UNITED STATES PATENT AND TRADEMARK OFFICE

10/584,457

Office Action Summary	Application No. 10/584,457	Applicant(s) BAUMANN ET AL.	
	Examiner RYAN F. PITARO	Art Unit 2174

Claims 7-15 are rejected under 35 U.S.C. 103(a) as being unpatentable over Ichinose ("Ichinose", US 6,819,990) in view of Isensee et al ("Isensee", US 5,550,559).

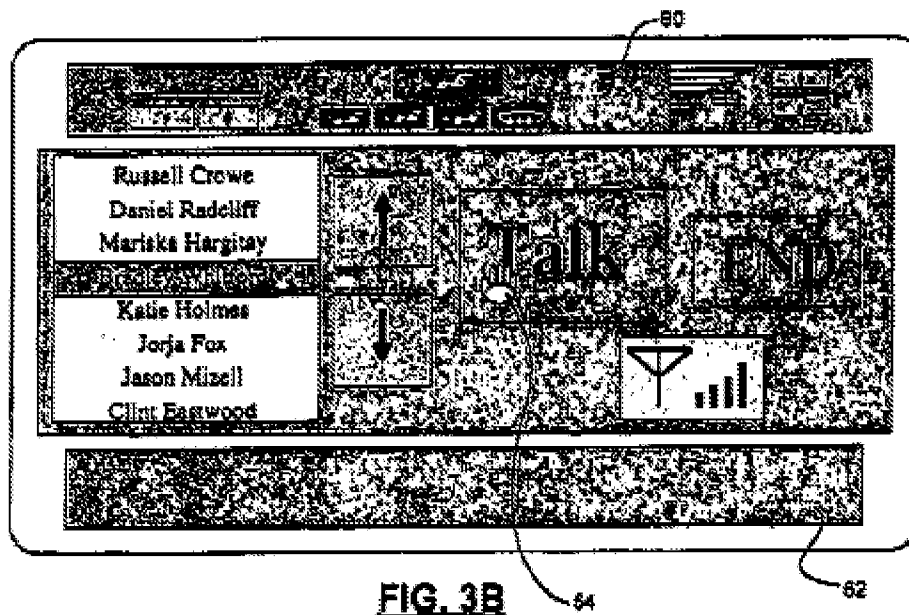
As per claim 7, Ichinose teaches a control system for a motor vehicle, comprising: a manual actuating device with a plurality of degrees of freedom of adjustment for at least one of selecting and activating entries in a menu structure with a plurality of menu levels (Column 3 lines 10-15, 45-60, Figure 6); a screen display having

a plurality of display areas for displaying the menu structure

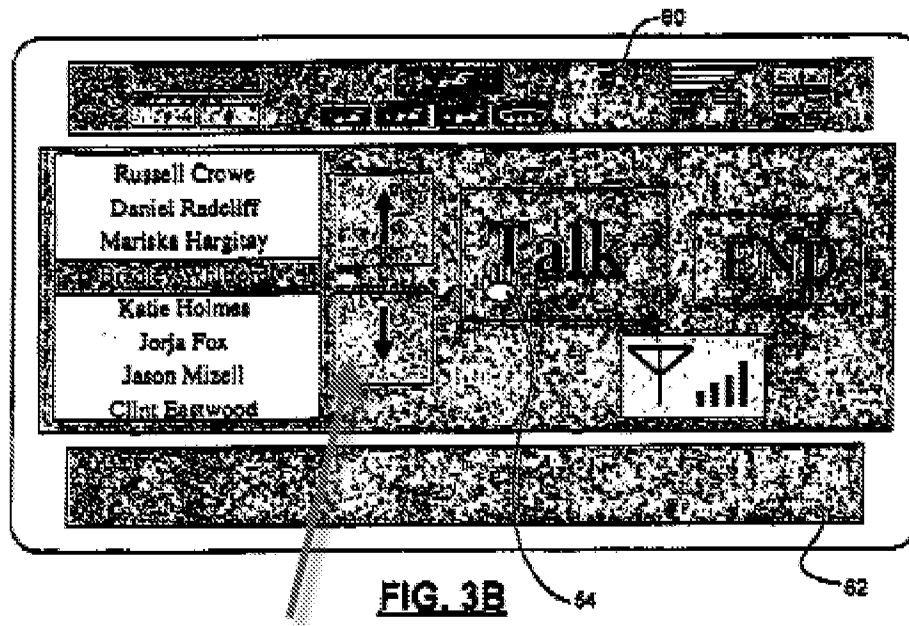
each of said display areas comprising at least one field for displaying one of the entries wherein, in an active one of said display areas in at least one menu level (60,54,62 above), a plurality of said entries are arranged in a first display area which is configured as a list (Figure 3b above , list).

Ichinose fails to distinctly point out an additional field for displaying the position of a currently selected entry. However, Isensee teaches at least one additional field for displaying the position of a currently selected entry in the list is activated and displayed if the number of entries exceeds a maximum number of entries which can be displayed in the list (Column 1 lines 35-50).

Therefore it would have been obvious to combine the additional scroll field of Isensee with the system of Ichinose. Motivation to do so would have been to make the graphical user interface more user friendly and efficient.

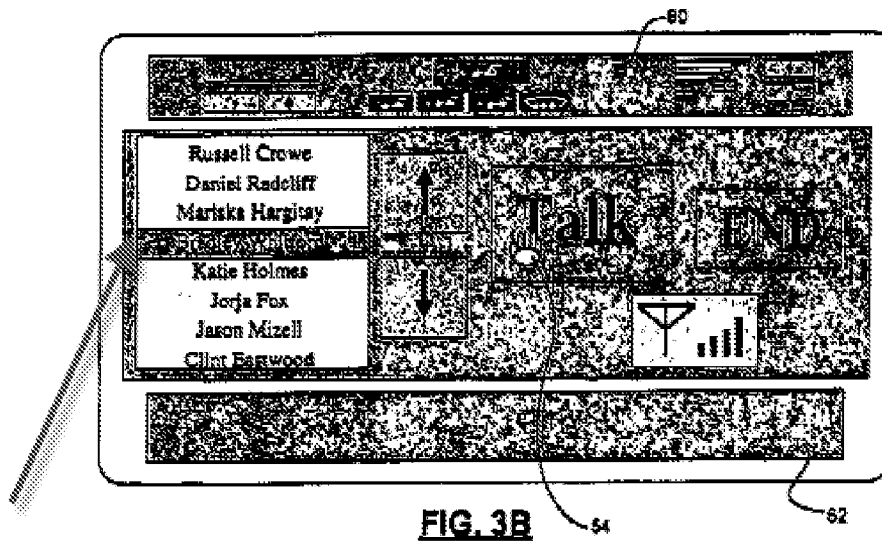
As per claim 12 ,Ichinose-Insensee teaches the control system as claimed in claim 9, wherein the particular graphic display of the marking is implemented with at least one of a different shape and a different color and a different size (Ichinose, see

figure below).

highlight

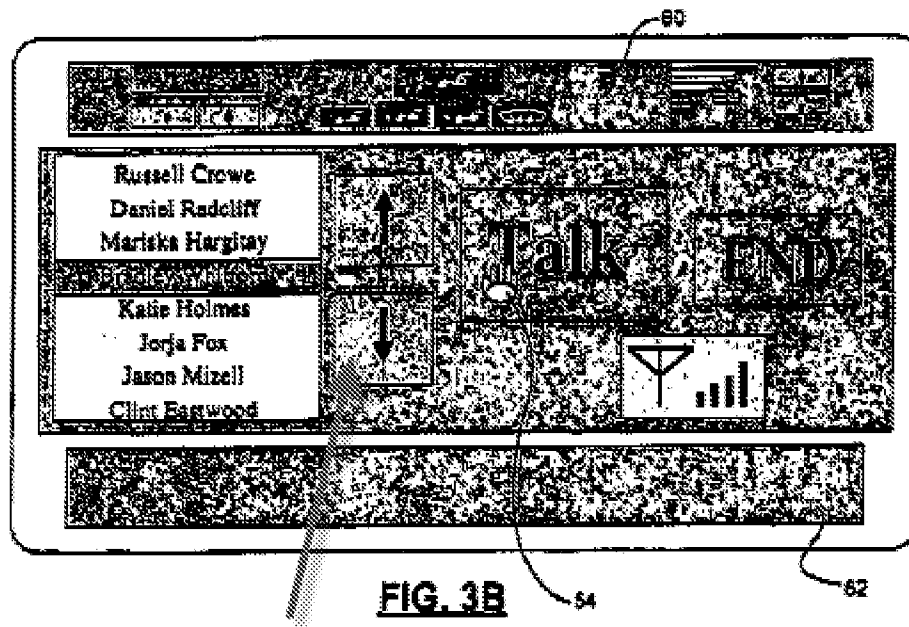
As per claim 13, Ichinose-Insensee teaches control system as claimed in claim 8, wherein the at least one additional field is arranged at least one of to the left and right of

the list.

additional field to the right

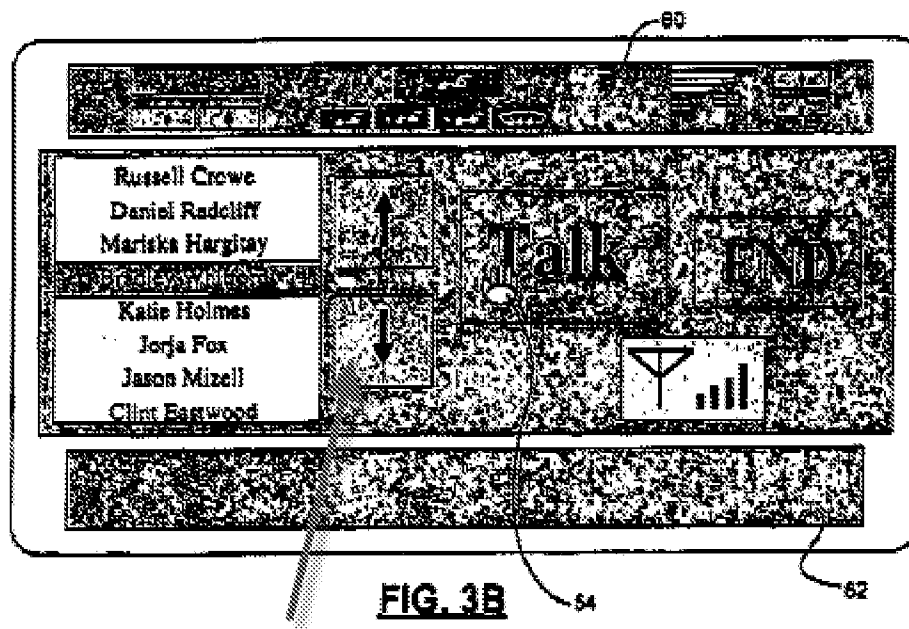
As per claim 14, Ichinose-Insensee teaches the control system as claimed in claim 9, wherein the at least one additional field is arranged at least one of to the left

and right of the list.

additional field to the right

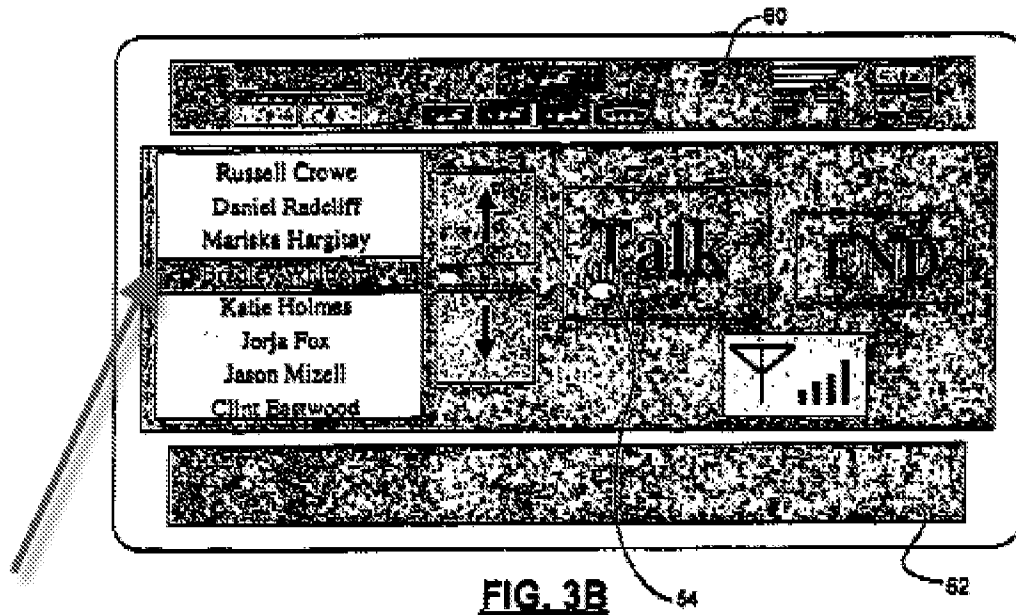
As per claim 15, Ichinose-Insensee teaches the control system as claimed in claim 11, wherein the particular graphic display of the marking is implemented with at

least one of a different shape and a different color and a different size.
